Report to the Sydney East Joint Regional Planning Panel (JRPP)

Application number	DA-539/2013/B
Site address	253-255 Oxford Street, Bondi Junction
Proposal	Modifications to street trees and front awning, balconies, internal modifications and changes to all floor levels resulting increase of overall building height to RL 150.30 (to lift overrun).
Approved development description	Demolition of buildings, construction of mixed use building with affordable housing component.
Date of lodgement	23 December 2014
Owner	Legpro14 Pty Ltd
Applicant	Mecone Pty Ltd
Submissions	One submission
Issues	Additional height, street trees
Recommendation	That the application be Approved subject to conditions of consent

Figure 2: Proposed changes to roof levels and plant

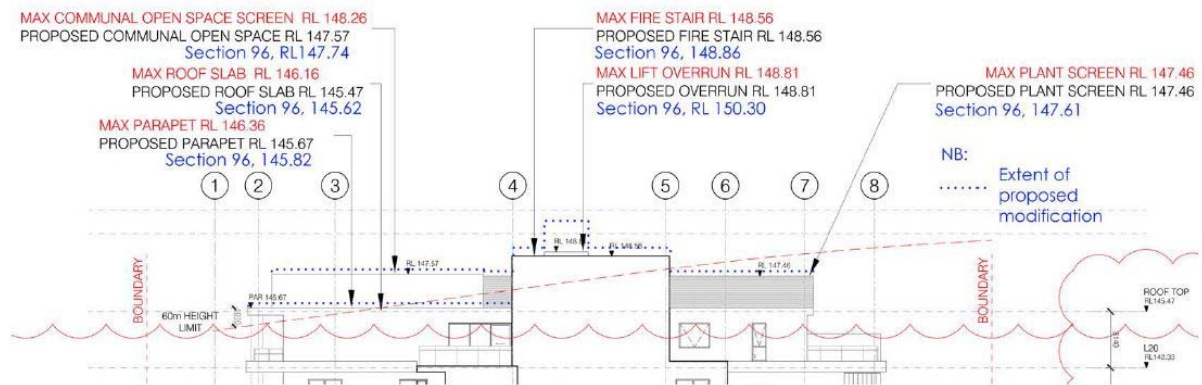
The Development Building Unit (DBU – The Planning manager group of Building Waverley) is concerned with any increase in height of the building after the extensive and considered deliberation in the Land and Environment Court proceedings, especially when justified for structural reasons with no evidence provided from a structural engineer or mechanical engineer (for the lift over run).

With regards to the plant equipment, the DBU agree with the experts opinion in the Land and Environment Court judgement who concluded that no part of the plant equipment on the roof should exceed RL 147.46. In this proposal, both the plant equipment and screen are proposed to be RL 147.61, this is 150mm higher than that bench mark set by those experts. This is a result of the building being increased by 150mm for structural reasons. Again the 150mm is considered a nominal figure and this is accepted.

The most significant height increase proposed is for the fire stairs enclosure and the lift over run. On the approved scheme, the fire stair and lift overrun were a similar height, with the lift overrun only 150mm higher than the fire stair. It is proposed in this modification that the lift over run is proposed to be 1.44m higher than the fire stair enclosure. The Statement of Environmental Effects offers no explanation for this significant increase, nor provided supporting information from either a mechanical engineer or Building Code of Australia Report to attest that these structure are required to be increased to such a level.

Given the extent of departure from the approved plans, and lack of technical evidence to support

an increased in the height of the fire stair and lift to be increased by 300mm - 1.5m respectively, the DBU are unwilling to accept that this modification is required and therefore this component of the proposal is not supported.

The overall increase in the height of the building is 150mm, which is considered a nominal increase and minor non compliance with the 60m height development standard. The building will remain to comply with the height control when viewed from Pine Lane. The roof plant and screening will exceed the height limit, however that will only occupy a portion of the roof. The increase to the height of the lift over run and stair is only supported on the basis that it will only be increased by 150mm in proportion to the building. A condition is recommended to this effect.
